Of an application by CJ Industries Ltd
for land use consent RM200488 for
gravel extraction and associated site
rehabilitation and amenity planting, for
land use consent RM200489 to establish
and use vehicle access on an unformed
legal road and erect associated signage,
and for a discharge permit to discharge
cleanfill to land RM220578

**REPLY EVIDENCE OF RHYS LEONARD HEGLEY ON BEHALF OF
CJ INDUSTRIES
ACOUSTICS**

21 April 2023

Report No. 19213NMPv3

Figure 1. Spectral Analysis of Excavator Loading a Truck

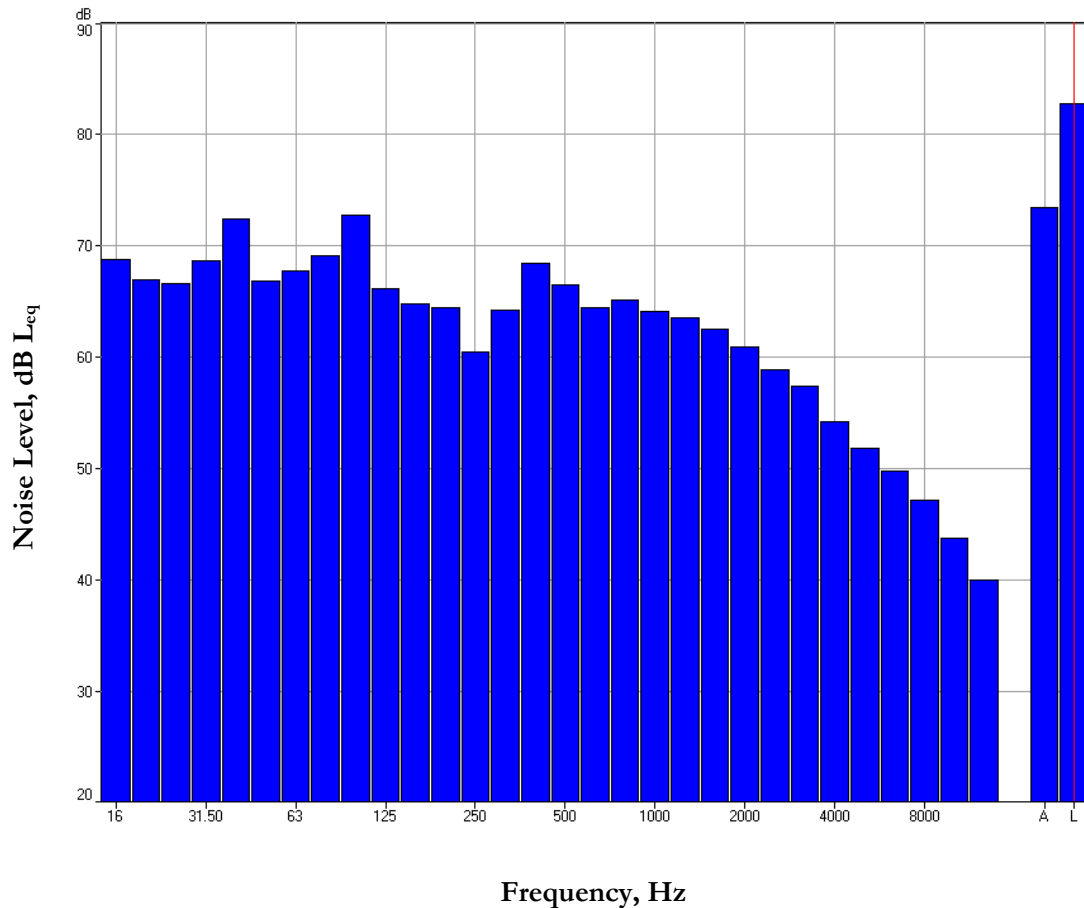
- 3.14 In his paragraph 32, Mr Lang provides a plot that shows a frequency analysis of a measurement he undertook of an excavator. The plot associated with paragraph 34 shows a frequency analysis of a YouTube video of an excavator. In both instances, the sample time is short, being approximately 0.2 and 0.3 seconds respectively. Such short measurements do not comply with the requirement of NZS 6802 that “*Measurement time intervals ... should cover any significant variations in the sound*”¹¹. My view is that the measurements are too short in duration for analysis.

- 3.16 Analysis of over 20 field measurements I have undertaken of excavators of various sizes show that none included a tonal component. I have been involved with multiple projects where excavators and loaders are proposed and note that no peer reviewer has ever queried the presence of a tone. I further note that from peer reviews I have conducted of the work of other consultants, none have included a tone.

- 3.17 Figure 1 below provides a spectral analysis of an excavator loading a truck with fractured rock over a representative 5 minutes, 32 seconds. Where a tone is present, it can be identified through a spike in noise level at a particular frequency. (Columns A and L are the overall noise level of the measurement, either A-weighted or Linea, and do not form part of the spectral analysis). No such spike is apparent and analysis in accordance with NZS 6802 confirms there is no tone.

3.18 Based on the above, I do not agree with Mr Lang's view¹² that any of the plant associated with the proposal should be assessed as having a tone.

Figure 1. Site Layout

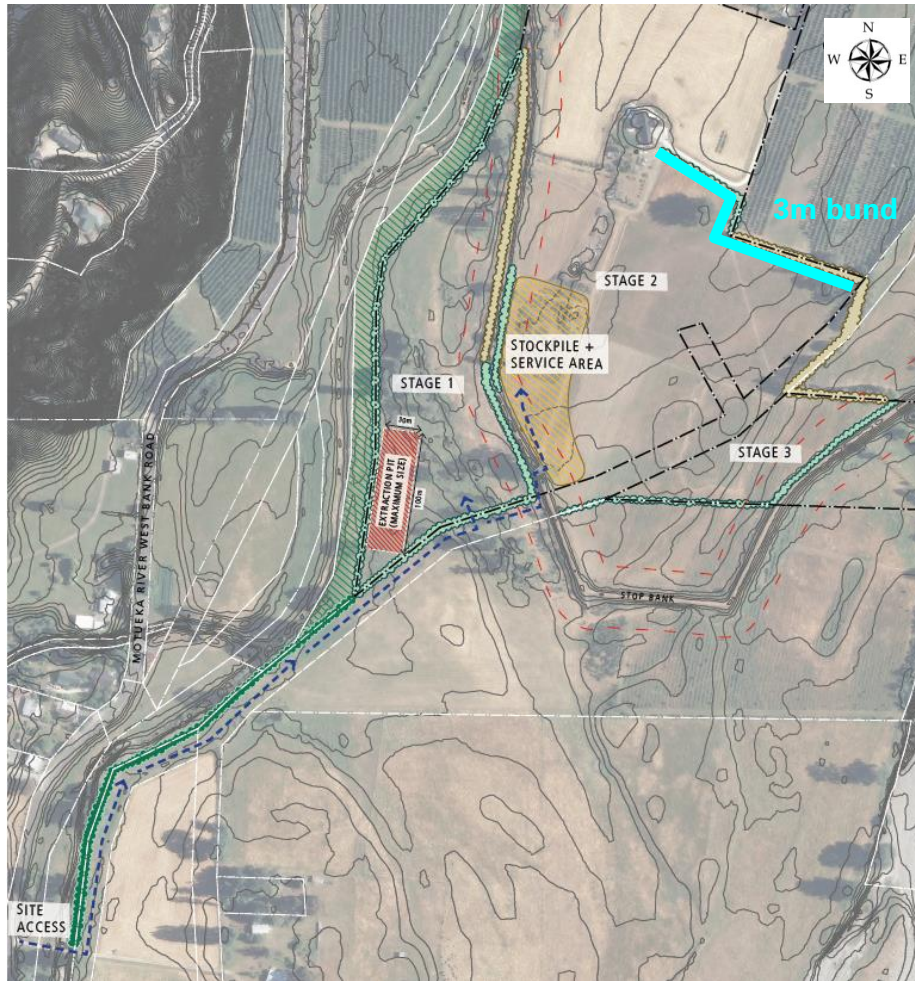
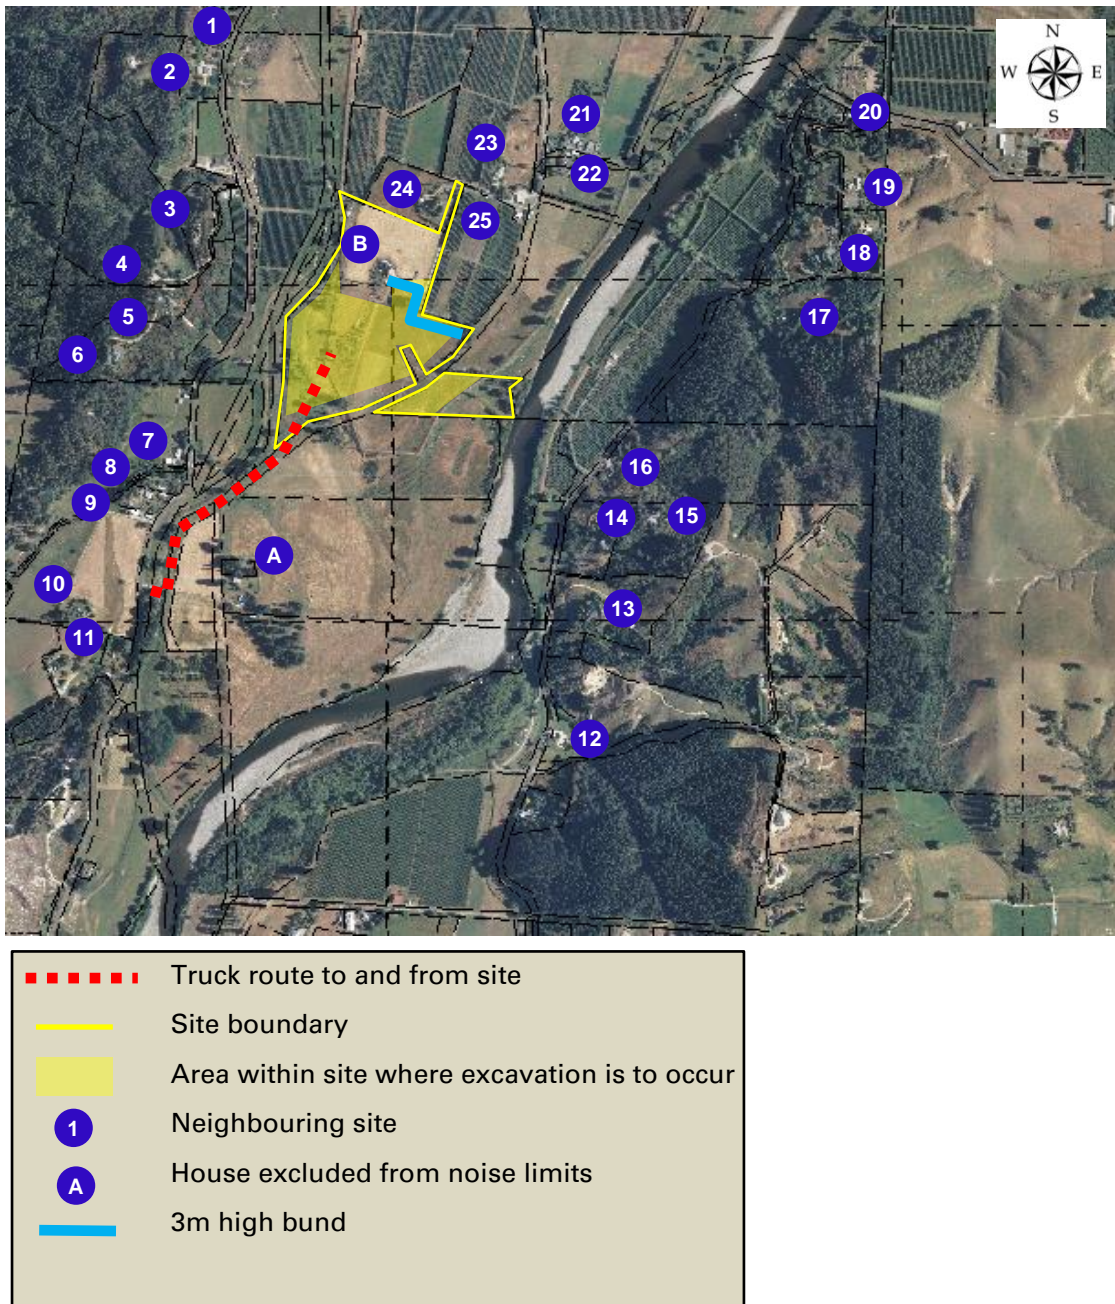
| Submission Paragraph (relating to NMP) | Response |
|--|--|
| 4. | <p>Section 4.a of the NMP proposes bund mitigation to screen the owners of 131 Peach Island Road from the effects of noise. If the owners wish, the bund could be removed. Table 1 of my evidence reports noise levels of 42 – 47dB L_{Aeq} to this site with the bund. Should it be removed, levels increase to 45 – 52dB L_{Aeq} and any noise condition relying on predicted levels of noise should be updated accordingly. However, I consider the noise bund is part of the applicant's steps to implement the best practicable option to manage noise.</p> |

- a) Construct a 3m high bund to screen the dwelling at 131 Peach Island Road, as shown on Figures 1 and 2.
- b) Consider site layout and the location of activities within the site with respect to sensitive receivers.
 1. Wherever excavation is undertaken, a bund with a top layer of topsoil to enable it to be grassed will be created between the excavation and the nearest neighbour (Figure 2).
 2. The storage and loading area will be located behind the stop bank.
- c) Identify plant options for undertaking specific work and consider the noise from each during selection, including:
 1. Larger loaders / excavators will make for quicker loading;

Figure 3. Chart for Addressing Complaints

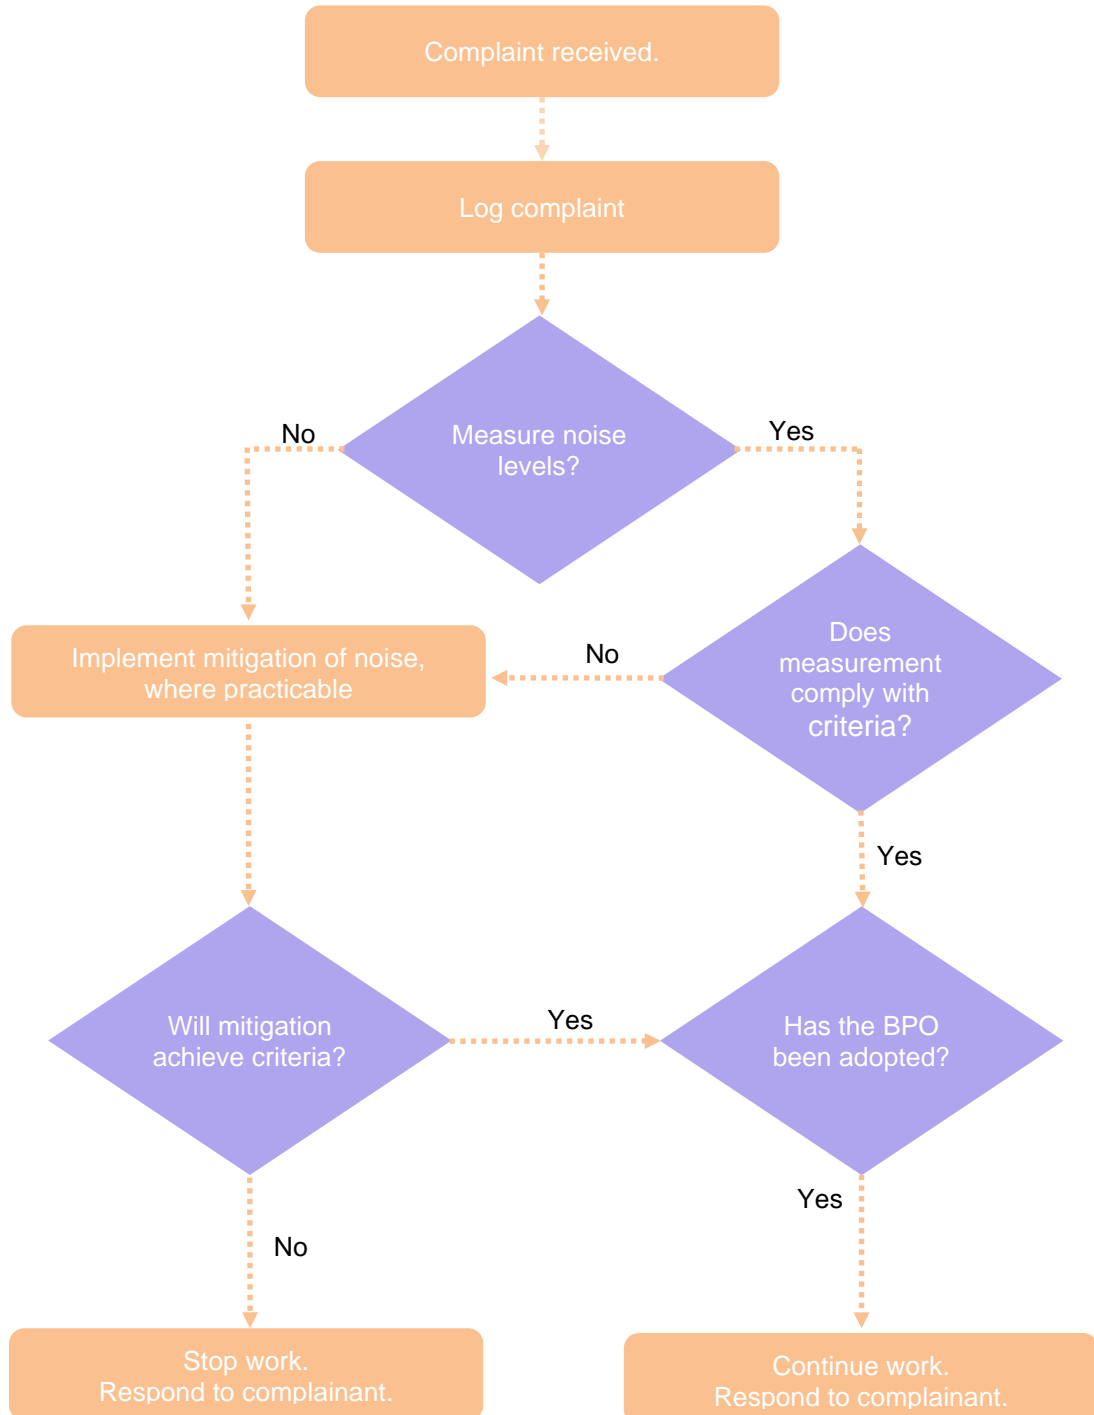
| Submission Paragraph (relating to NMP) | Response |
|---|---|
| 7. | Section 8 of the NMP also includes a flow chart for addressing complaints. My view is that it will not always be necessary to measure the noise. For example, if equipment breaks, resulting in increased noise levels, a pragmatic approach would be to simply turn the equipment off, fix it and then continue rather than introduce noise measurements to the process. |

| Submission Paragraph | Response |
|-----------------------------|---|
| 116. | I have suggested a modification to the flow chart for addressing complaints (Figure 3) in an updated version 3 of the NMP. |
